# ADA Curb Ramp New Construction Inspection Form (Parallel)

NW Timeric

23885.56

NW North

PARALLEL RAMP (PL)

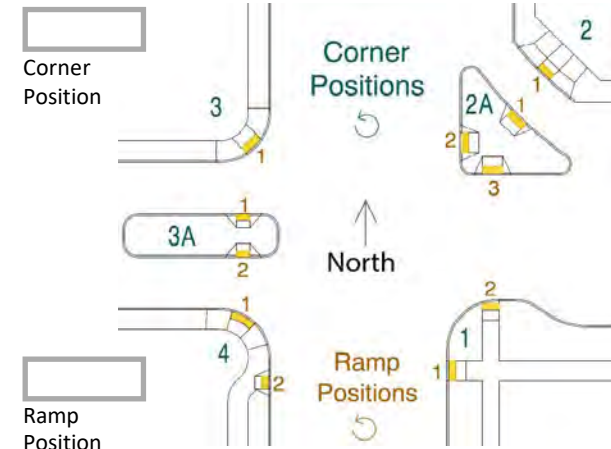
4.3  $\leq |5.0\%|$  ☐  $> |5.0\%|$  ☒

7.1  $\leq 2.0\%$  ☐  $> 2.0\%$  ☒

5.7  $\leq 2.0\%$  ☐  $> 2.0\%$  ☒

3.85  $\geq 4.0'$  ☐  $< 4.0'$  ☒

Comments:  
NTD RR1 TS Fail
